DAVID STARR JORDAN
HIGH SCHOOL
STRUCTURAL STRENGTHENING
AND MODERNIZATION OF
AUDITORIUM AND BOILER HOUSE
2245 E. 103rd ST., LOS ANGELES, CAL.
STATE OF CALIFORNIA - DEPARTMENT OF GENERAL SERVICES
AS RE-DESIGNED FOR RECONSTRUCTION
25132 APPROVED NOV 20 1964

INDEX OF SHEETS, SCHEDULE AND MOSAIC PANEL DETAILS

DAVID STARR JORDAN
 HIGH SCHOOL
 STRUCTURAL STRENGTHENING
 AND MODERNIZATION OF
 AUDITORIUM AND BOILER HOUSE
 2265 E. 103RD ST., LOS ANGELES, CAL.
 STATE OF CALIFORNIA - DEPARTMENT OF GENERAL SERVICES
 DIVISION OF ARCHITECTURE AND CONSTRUCTION
 AS REVISED APR 13 1965
 25132 APPROVED NOV 20 1964
 APPLICATION NO. 100
 PER S. Morgan

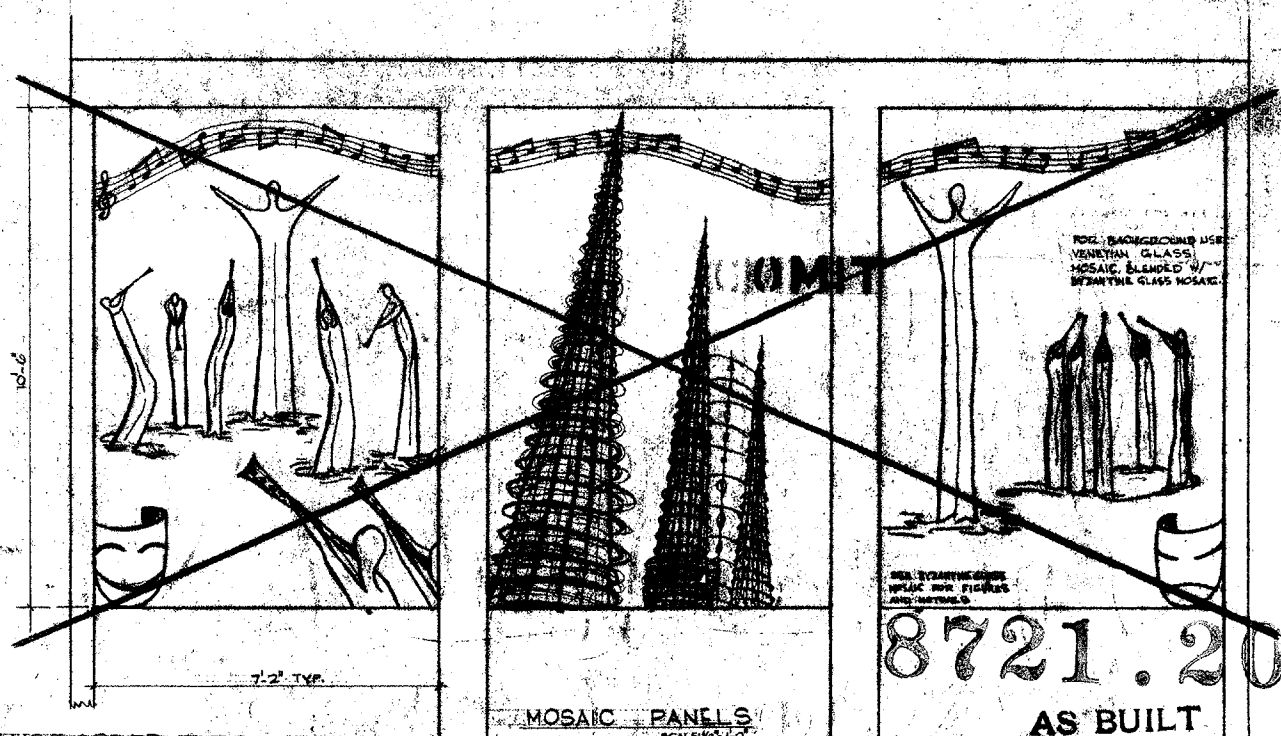
2 CHANGE ORDER T-509 - FIN RECESSES in floor, left when existing tile floors and partitions were removed.

3 CHG. ORDER T-513 - FRAME NEW DOOR LEANERS

Δ: REVISED FINISH SCHEDULE. Ceilings omitted Rooms 108, 109, 110, 113, 114, 115, 202, 203, 204 and 205. Stage walls exposed const. Foyer ceiling changed from Baranille to flat

FIRST FLOOR PLAN, WEST ELEVATION AND DETAILS
 NORMAN B. GREEN
 STRUCTURAL ENGINEER
 548 S. SPRING ST., LOS ANGELES, CAL.
 REG. NO. 115 Norman B. Green
 PREPARED FOR THE
 BOARD OF EDUCATION
 LOS ANGELES SCHOOL DISTRICT
 DATE 11/20/64
 D.R.E. N.M.K.
 C.L.B.
 SHEET
A-3

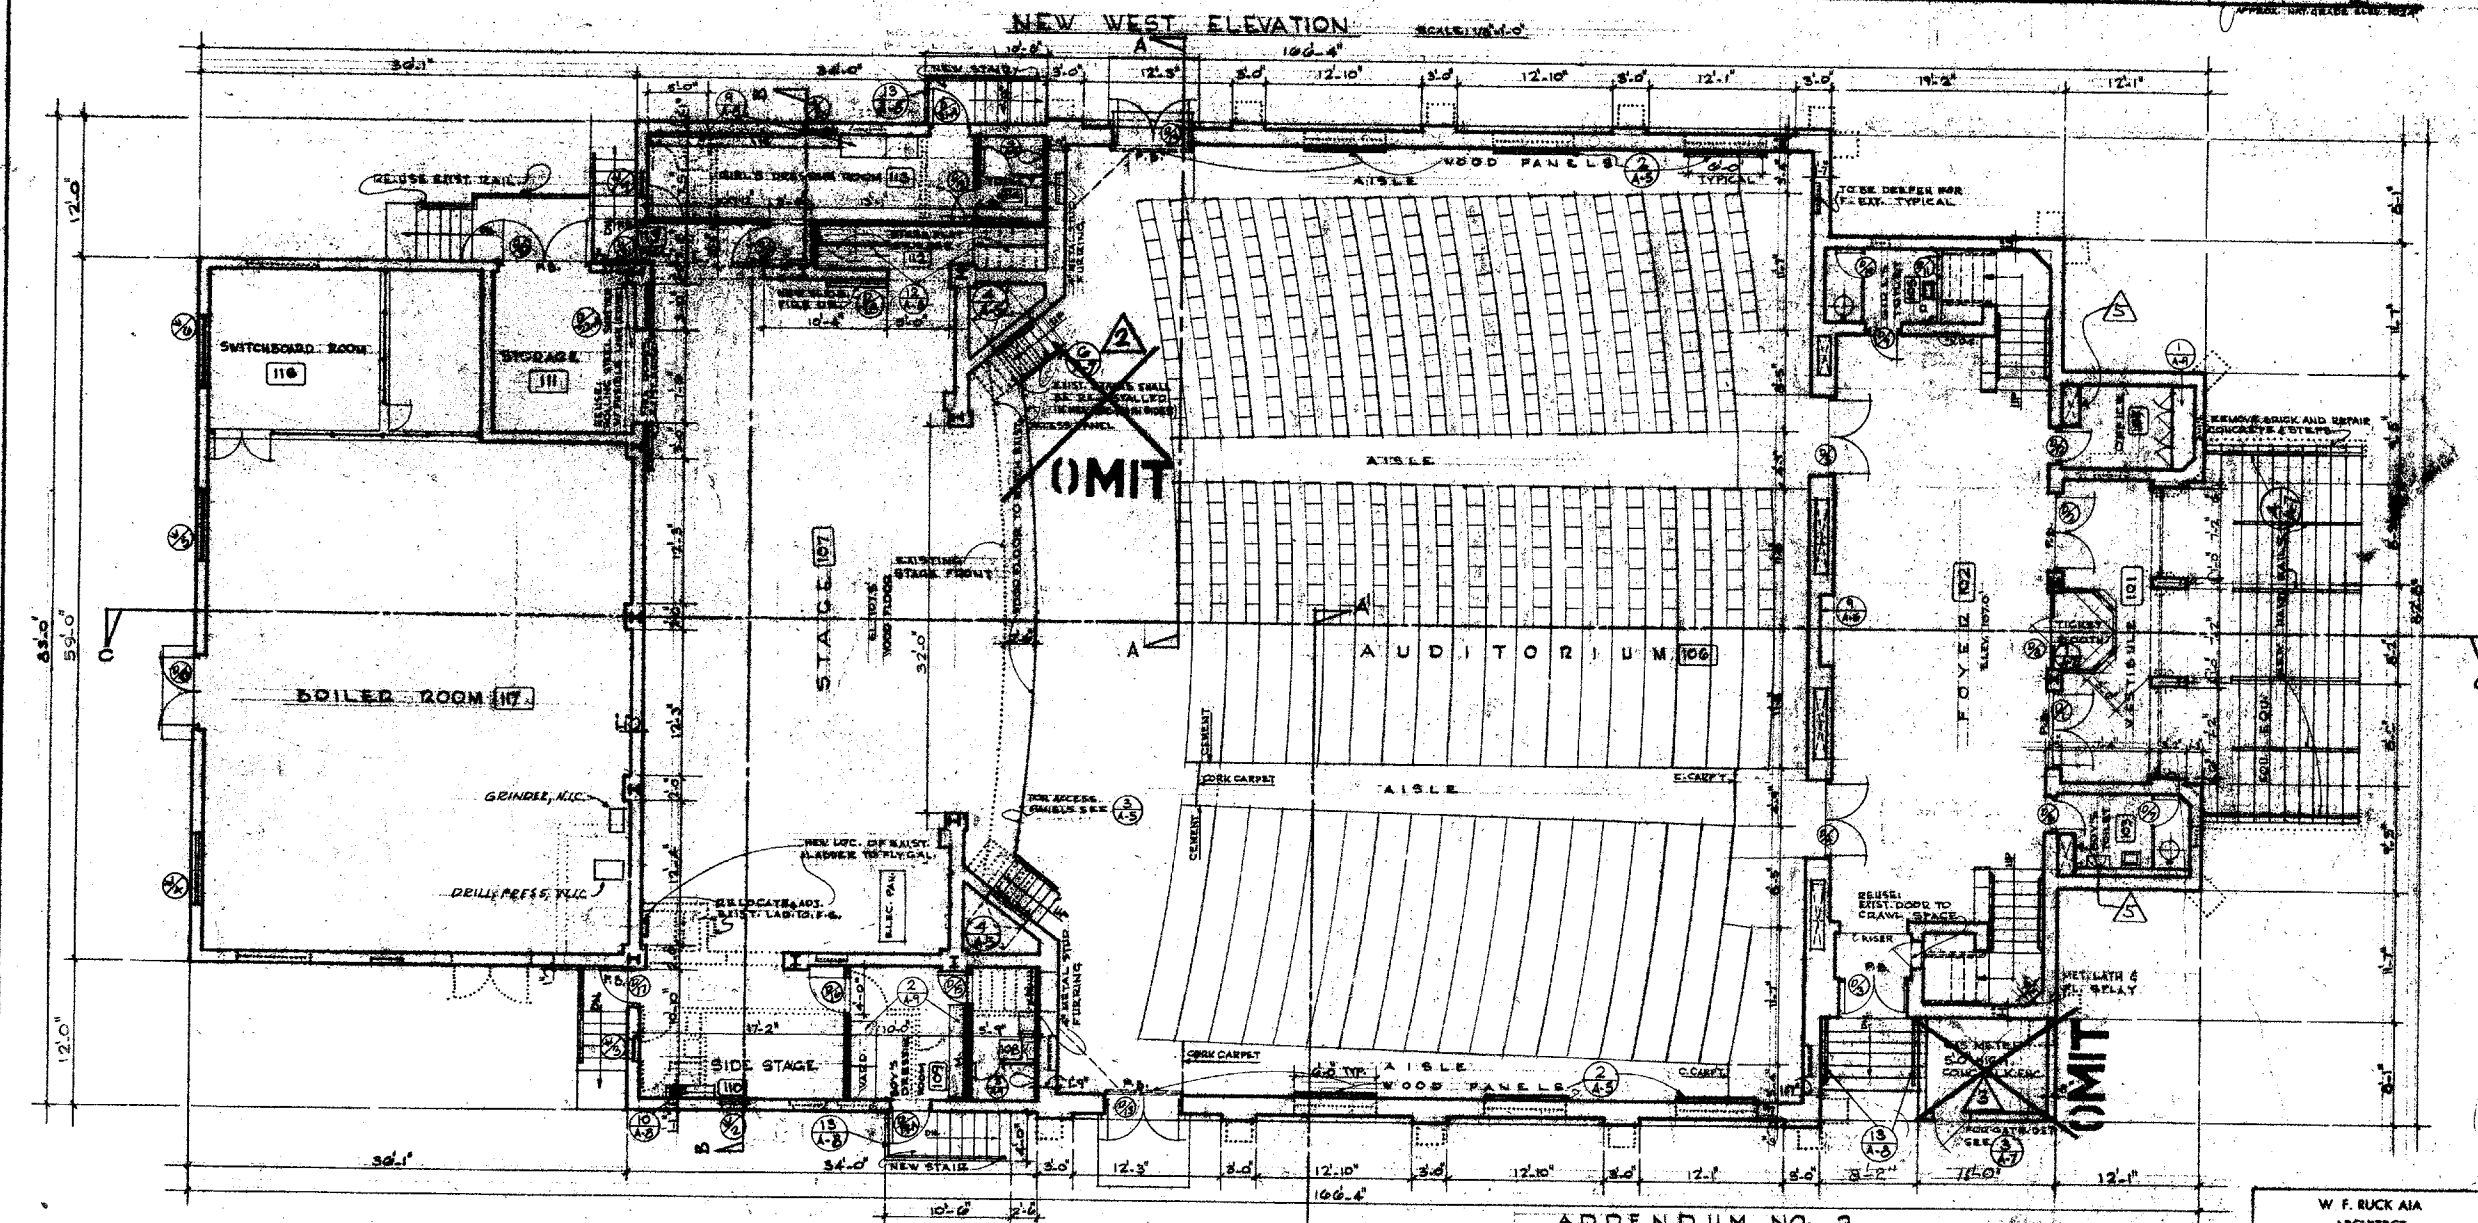
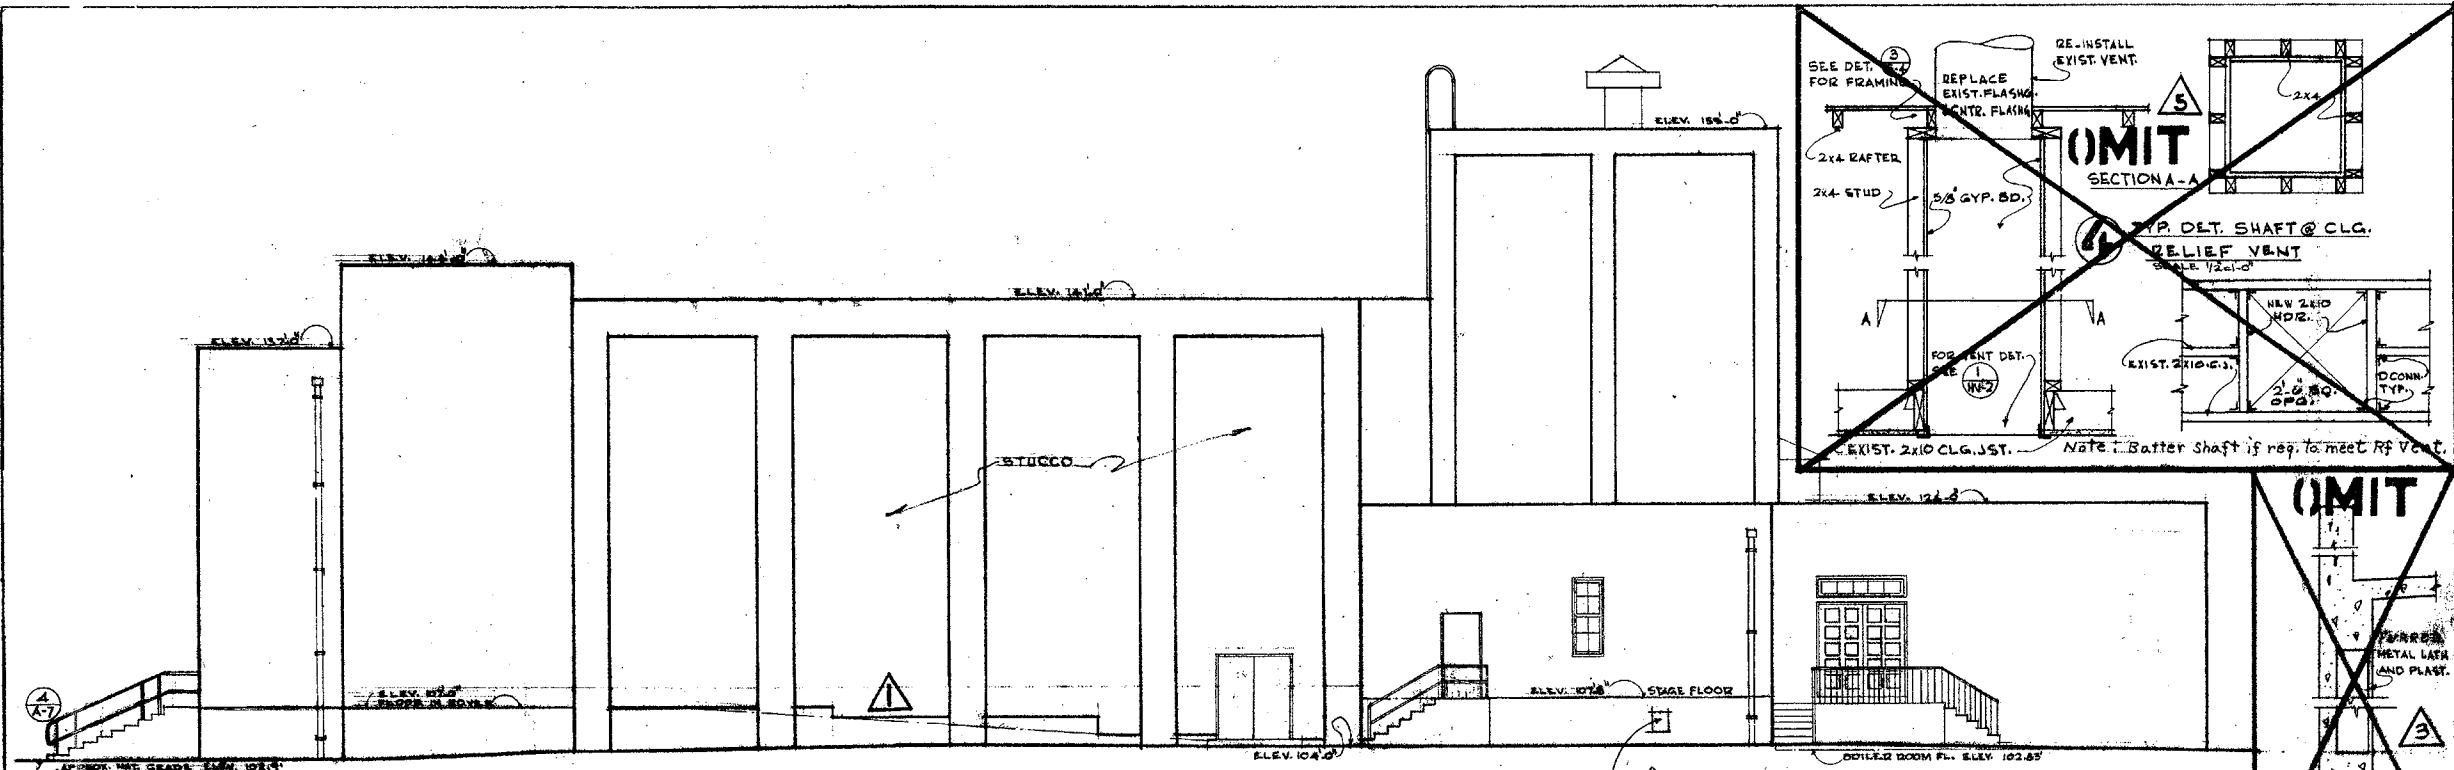
ADDENDUM NO. 2
 EXTEND & QUOTE TO THE TOP OF EXISTING CONC.
 LEAVE STAGE FRONT & STAIRS AS THEY EXIST
 OMIT CONC. BLOCK ENCL. & GATE
 CHANGE BARREL CLG. TO A FLAT SUSP. MET. L. & PL. CLG.

BALCONY AND CEILING PLAN

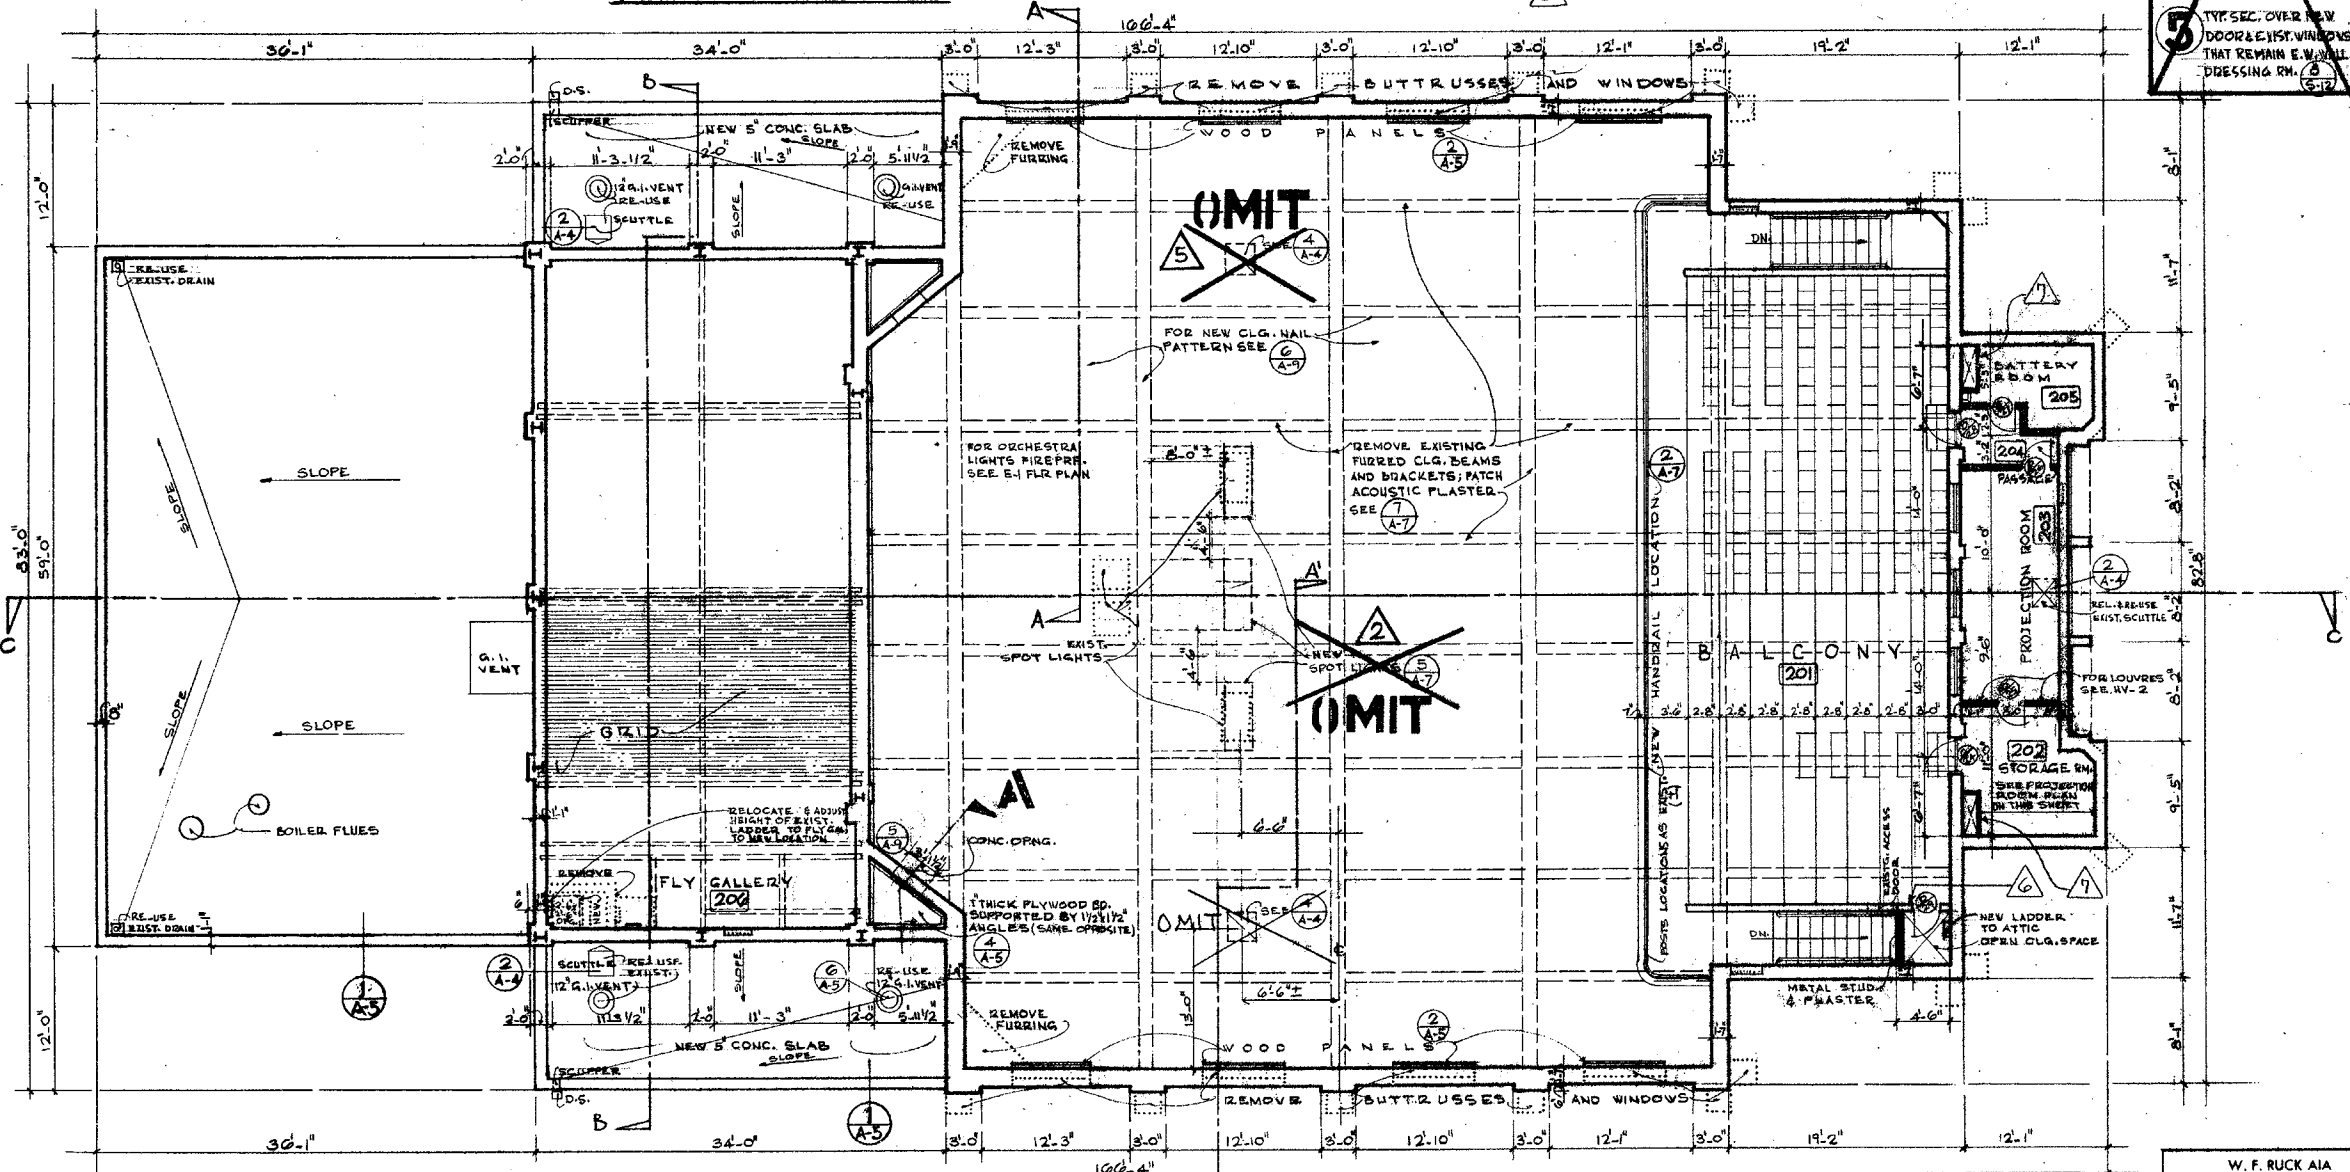
- △ SAME AS WEST ELEV.
- △ LEAVE EXIST. SPOT LIGHTS & THEIR ACCESS CATWALK
- △ OMIT DETAIL 5
- △ OMIT DETAIL 1
- △ OMIT RELIEF VENTS

- △ CHANGE ORDER T-512 - New steel studs and plaster east side ladder enclosure
- △ do do do - Plaster furring around duct risers.
- △ CHANGE ORDER T-513 - New steel grating closure of existing opening.
